British National Committee
on Large Dams (BNCOLD)

Reservoirs 1986

Discussion Proceedings

3/6 September, 1986

Fig. B.1. Section through an arch dam

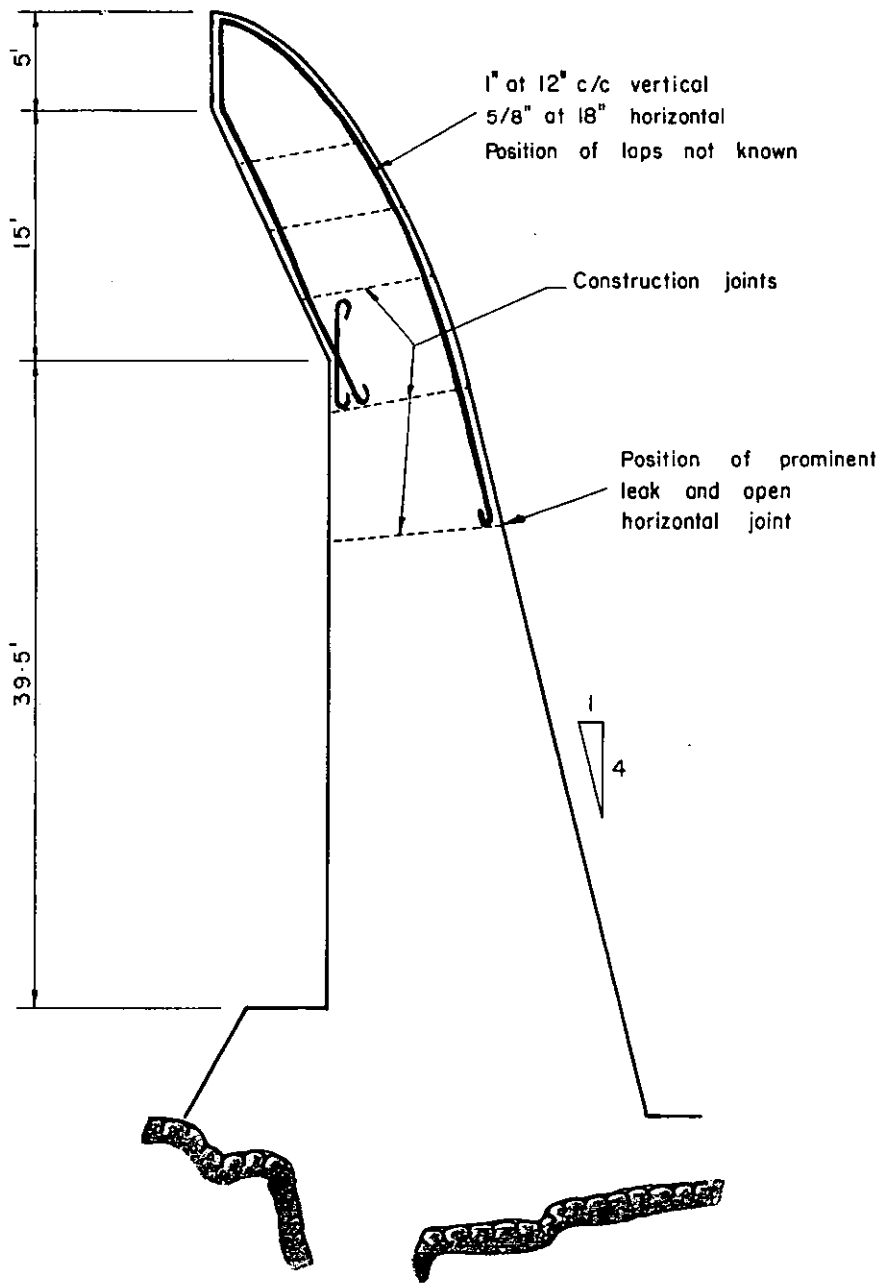
The downstream face was reinforced above a certain level and this in itself would lead to very difficult concreting conditions. The individual cantilevers had a calculable tensile stress in the downstream face. The rate at which they were raised would need to provide time for the concrete strength to develop, stage by stage, so that it bonded adequately with the reinforcement. Inadequate concrete strength at any stage of the construction would increase the tensile stresses still further, inevitably leading to local bond failure and micro cracking.

A further aspect to consider was the principle of adopting contraction joints in an arch. If these were concreted before the concrete in the main blocks had been given adequate time to shrink, joints would continue to open up even after the contraction joints were concreted so that localized non-elastic movements could occur when the dam was loaded or unloaded. Concrete of the thickness

involved in this dam would have continued shrinking for a long time after construction as it was not cooled.

Less than 20 years after the dam was completed there was extensive cracking on the downstream face, reflecting the position of the reinforcement and extensive leakage along the contraction joints. There was also a prominent horizontal joint along the downstream face immediately below the level of the reinforcement which was more than 5 mm open. The present appearance of the dam was most unsatisfactory.

Fig. B.2. Closure detail in a buttress

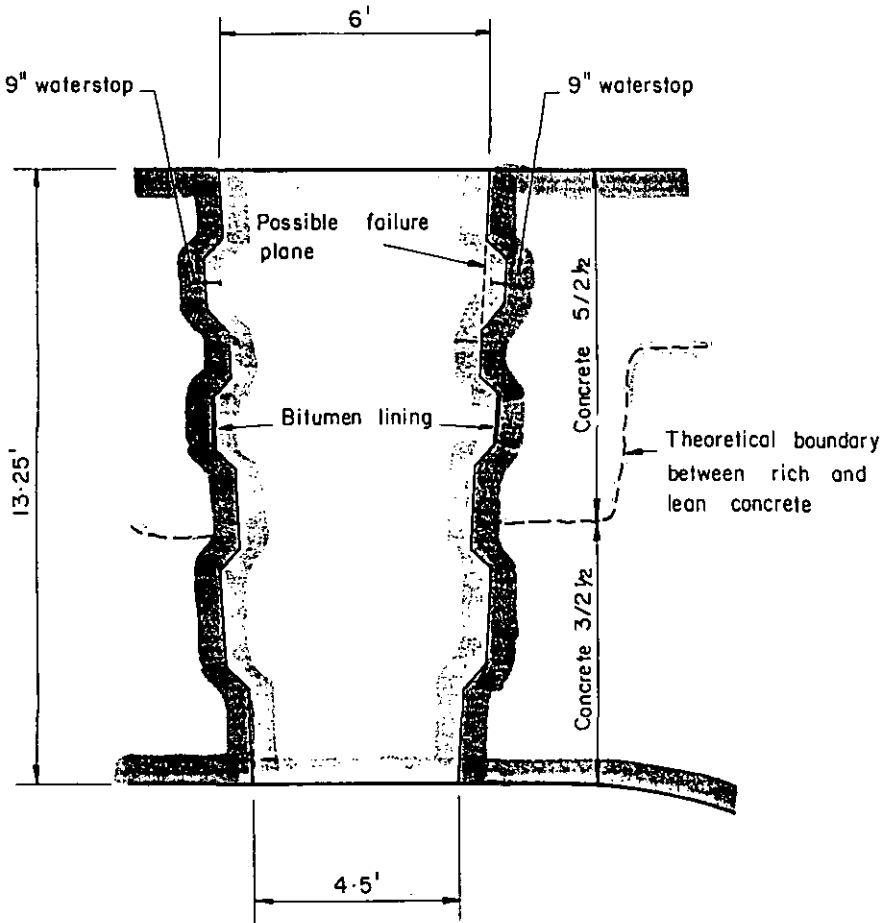
A slide (not reproduced) showed a common form of closure detail, this time in a buttress (Fig. B.2).

The water stop was located in the keyway. When the concrete in the main buttress shrank, the wedge was prevented from moving downstream by the keys which therefore picked up the horizontal load. The key incorporating the waterstop was invariably weakened by the waterstop itself and tended to shear thereby rendering the waterstop entirely ineffective. The result was illustrated by a slide (not reproduced) showing extensive seepage discolouration along joints on the downstream face.

Fig. 2.2. Vertical section of intake, gate and penstock

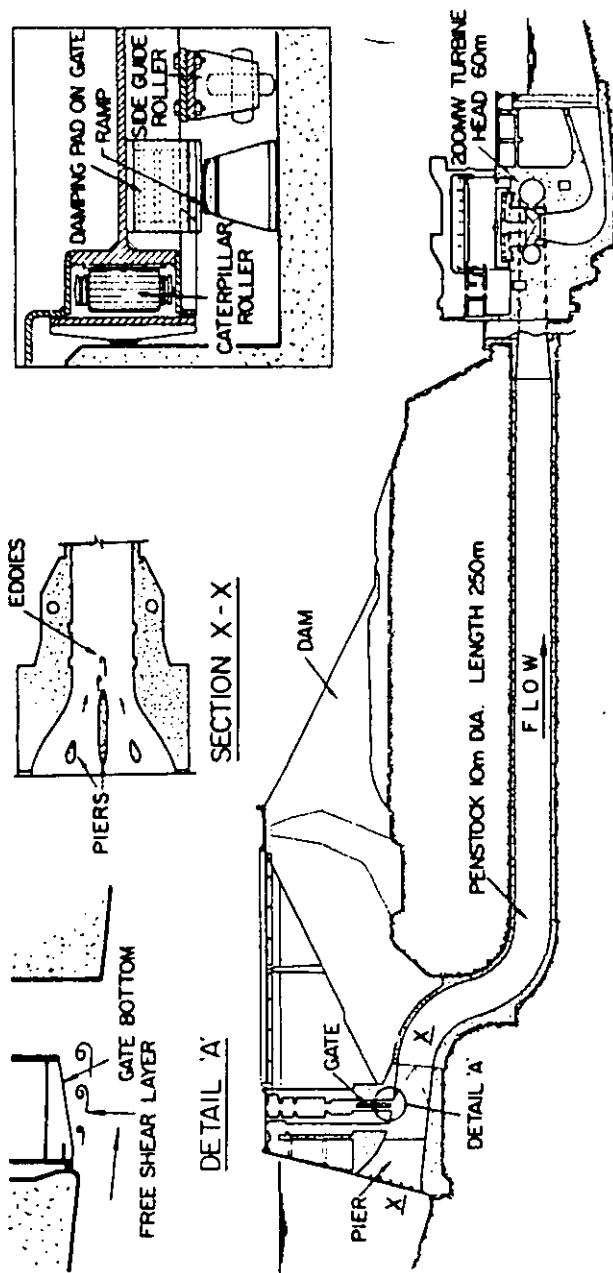
The underside of the gate was subjected to eddies arising from the main vertical splitter and subsidiary horizontal screen supporting beams, which between them produced a wide range of frequencies for single and double eddies which included the gate vibration frequency. It was also possible to prove that the penstock downstream of the gate could have a frequency resonant with the gate frequency thereby amplifying the eddy forces acting on the underside of the gate. It should be appreciated that the range of the calculable frequencies was very large. Once the initiating mechanism had been identified, gate vibrations were eliminated completely by providing a low horizontal damping force on the very top of the gate (see Fig. 2.2).

In reply to Mr Martin, the authors said that gates had to be profiled only when they were to be operated under flow conditions. If they were rope suspended, and if the suspension was of appreciable length, there was a high risk of gate vibration under flow conditions because of the low natural period of vibration of the system. If an attempt was made to compensate for this by damping by increasing the friction of the gate reaction faces, it might not close under gravity.

If emergency closure had to be taken into account, the bottom edge had to be profiled and the gate should preferably be operated by a hydraulic ram connected to the gate by piston and rod extensions.

Fig. 3.1. Sections through dam

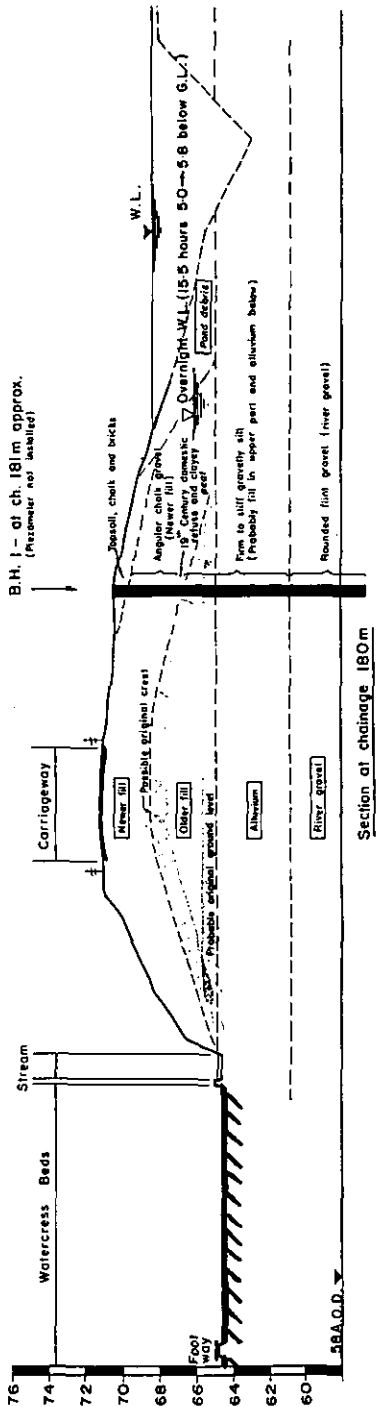
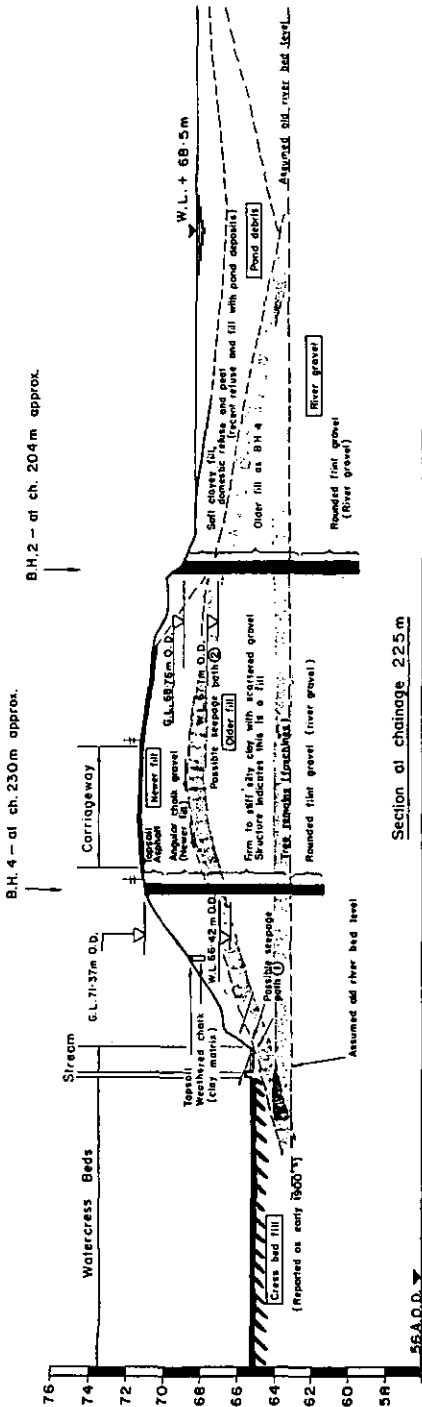
Mr W.T. MEE (Sir Alexander Gibb & Partners) raised, by reference to a specific case, the question of ownership and responsibility of the safety of a reservoir. Although not actually challenged or tested in the courts, he had been informed that the owner of the water was responsible for reservoir safety and if this was in fact true, one might well question the justice of it. The dam in question (see Fig. 3.1) impounded a small, pleasant 'pond' which just qualified for the Reservoirs Act 1975. The whole area had extensive watercress beds, and these also occurred immediately downstream of the dam.

The original dam was completed to a level some 10 ft lower than at present over 700 years ago. The construction material was lumps of chalk which the villagers carried in reed baskets and placed in the marsh. The original dam profile was conservative and capable of some limited overtopping. The events described below then occurred apparently without any reference to the owner of the water who considered that he owned only the water and the upstream face of the dam.

1. At some time, probably in the last century, the dam was raised 10 ft to accommodate a public highway and thereby the downstream slope was considerably steepened.
2. At some time in the last century the watercress beds were widened and a drain constructed along the toe of the dam. In order to do this, the toe of the dam was removed and

thereby the dam itself was made even steeper. This inevitably caused localized slips which were repaired, presumably by the owner of the drain. These repairs contained 8 inch pipes at about 20 ft centres which carried appreciable volumes of seepage water. The water-cress beds themselves had artesian flow.

With one owner of the water and the upstream face, a second owner of the downstream face and watercress beds, presumably a responsibility by the Highway Authority for the roadway, and a total of 5 additional owners who had properties around the spillway, which discharged through the ends of their gardens, the application of responsibility should, perhaps, be considered further. Mr Mee asked for guidance from the Chair and the delegates on this point. (See page 31 for reply from Mr Agnew.)

Fig. 5.1. Yorkshire Water, Western Division - crest settlement of central core dams

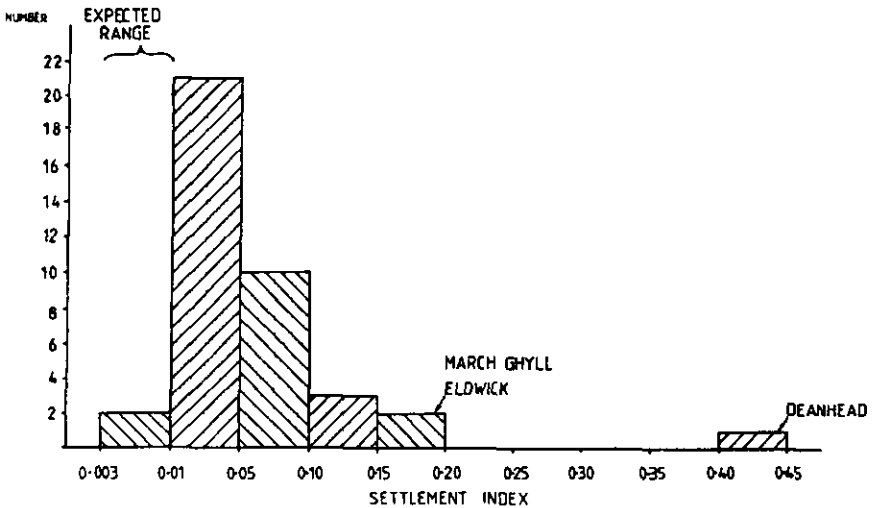
Mr J.R. CLAYDON (Yorkshire Water, Western Division), in opening the discussion, said that Dr Charles had raised several topics in his interesting paper. Mr Claydon would like to comment on the settlement index as defined on page 128 of the paper.

The distribution of settlement indices for this sample was shown in histogram form in Fig. 5.1. There were 39 dams in the sample. The oldest was built in 1825, the newest in 1970. Their heights ranged from 9 m to 54 m and the period of record used varied from 1 year to 7 years depending on the length of time for which accurate data were available.

Only two dams had settlement indices in the range predicted by Dr Charles. One of these was Scammonden, a rockfill dam with a rolled clay core; the other was a rockfill dam with a puddle clay core built in 1907.

All the other dams had higher settlement indices, the largest group of 21 being in the range 0.01 to 0.05. There was a skewed distribution with all the remainder, except one, lying below 0.20. Commenting on the three highest settlement indices:

Fig. 5.2. Dean Head Dam - settlement 1977-1985

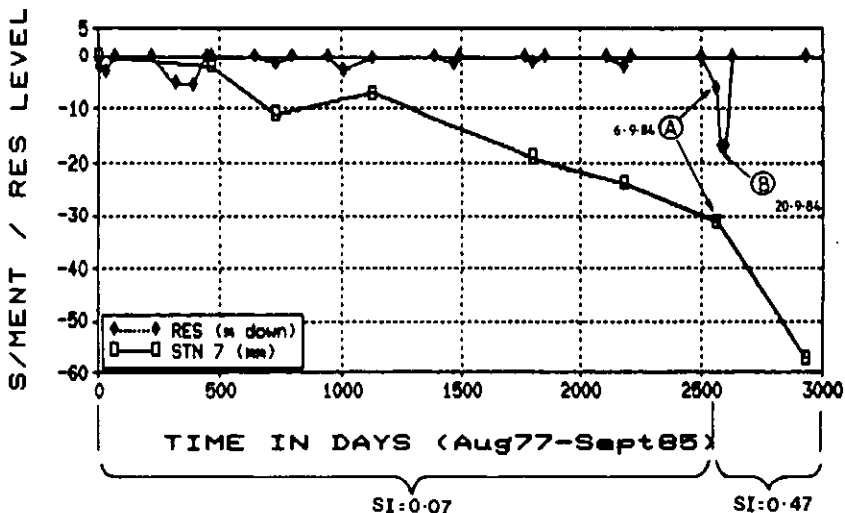
Dean Head, Settlement Index 0.45

This was 19 metres high, built in 1840. The settlement record for the highest cross section for the period from 1977 to 1985 was shown in Fig. 5.2. This illustrated how the way in which reservoirs were operated influenced the settlement behaviour of dams. From August 1977 until August 1984 the reservoir was little used; however, in 1984, pipework connections enabled water to be taken to supply. It was drawn down by 5.9 m when the crest was levelled on 6th September 1984 (point A on Fig. 5.2). At this date the settlement rate was still linear with respect to time. The crest was not levelled again until September 1985, when 26 mm settlement was noted. In this period the reservoir had been completely emptied by 20th September 1984 (point B) and refilled again by 14th November 1984. Mr Claydon suggested that the rate of settlement was affected by the rate of drawdown, the extent of drawdown, and possibly also by the numbers of cycles of drawing down and refilling.

Fig. 5.3. Ramsden Dam - settlement 1977-1985

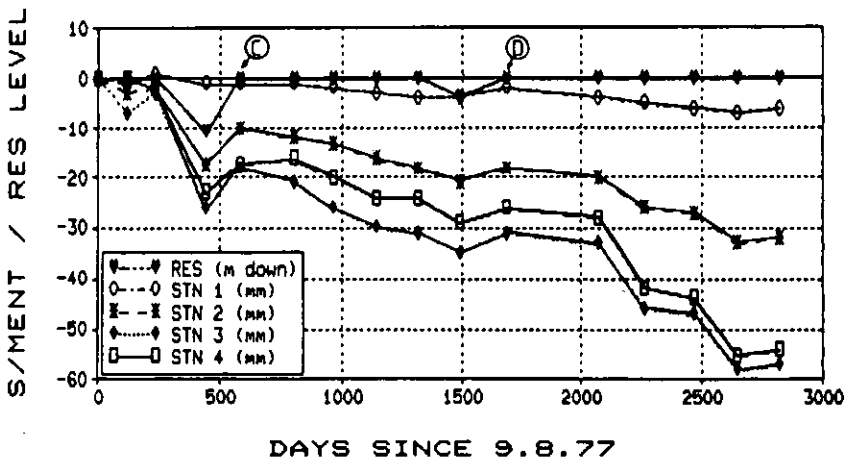
Figure 5.3 showed the settlement of four stations on the crest of Ramsden Dam, which was 22 m high and was built in 1892. These showed quite clearly that the crest not only fell on drawdown, but that it rose on refilling (points C and D). At this dam they had also recorded horizontal movement associated with reservoir draw-down, with the crest moving upstream on drawing down and moving a greater distance downstream on refilling.

He suggested that these data showed that the settlement pattern was affected by reservoir operation and that the subject needed further investigation.

Fig. 6.1.1. Properties of puddle clay core at March Ghyll dam

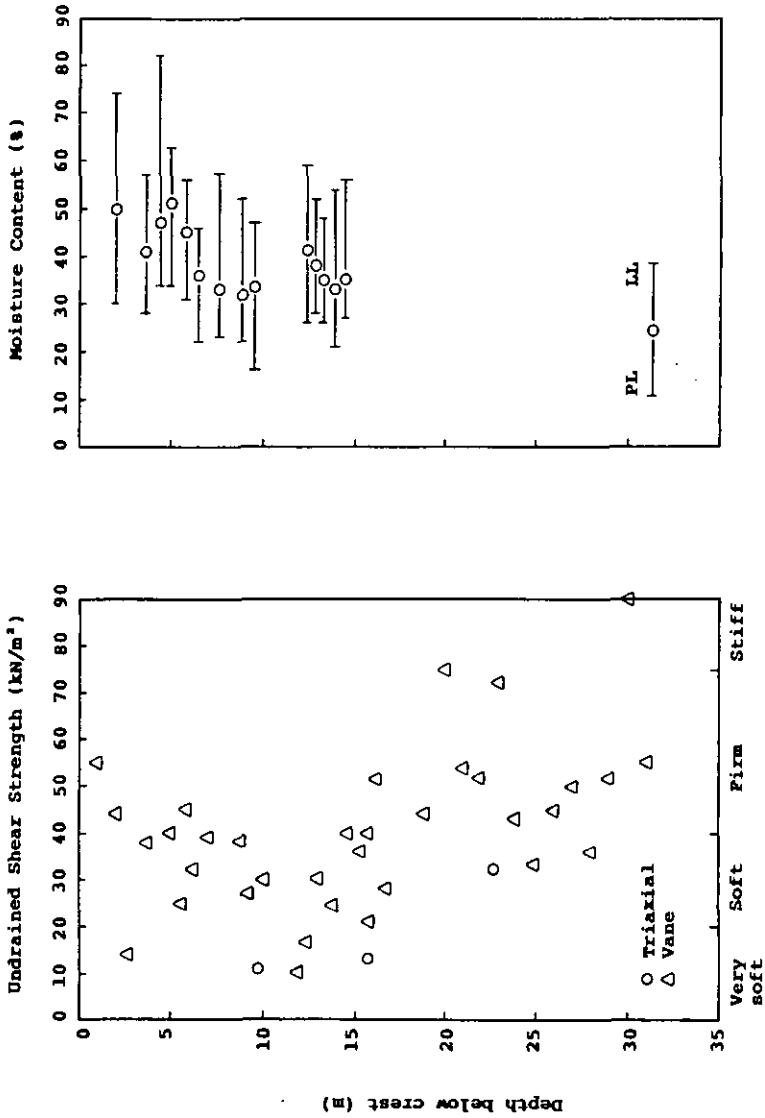
Dr R.S. PUGH (A.G. Weeks & Partners) said that Dr Charles had proposed the use of a 'secondary compression index' to assess whether the settlements being experienced by an earth dam should be cause for concern. Data from settlement measurements of earth dams (given by a previous speaker) illustrated that this index varied considerably for earth dams which were not apparently showing signs of distress. In particular, the problems associated with changing rates of settlement as reservoir water level was altered were highlighted and acknowledged by Dr Charles. The coefficient of secondary consolidation of natural soft deposits was also known to vary widely with, for example, the water content and plasticity of the soil. It was difficult to measure the

coefficient of secondary consolidation under laboratory conditions and even more difficult to separate it from other effects in the field. Given the variety of clays used in dam construction, the wide range of water contents likely at the end of primary consolidation and the cyclic changes in water content which would occur during reservoir operation, he wondered if the index proposed by Dr Charles would in fact be sensitive enough to predict detrimental changes in embankment behaviour. (See page 83 for reply from Dr Charles.)
